Product Change Notification

Change Notification #: 113532 - 00
Change Title: Intel® Server Chassis P4304XXSFCN
PCN 113532-00, Product Design,
Update Hard Disk Drive Tray to add 2
latches and labels
Date of Publication: December 22, 2014

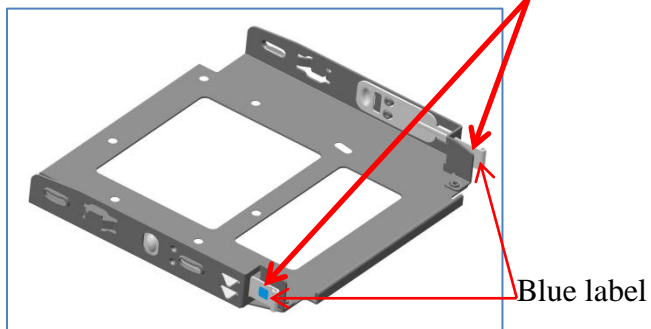
Add two latches and labels for the fixed HDD (Hard Disk Drive) tray to enhance the robustness of the HDD tray and indicate the touch point for the HDD tray assembly.
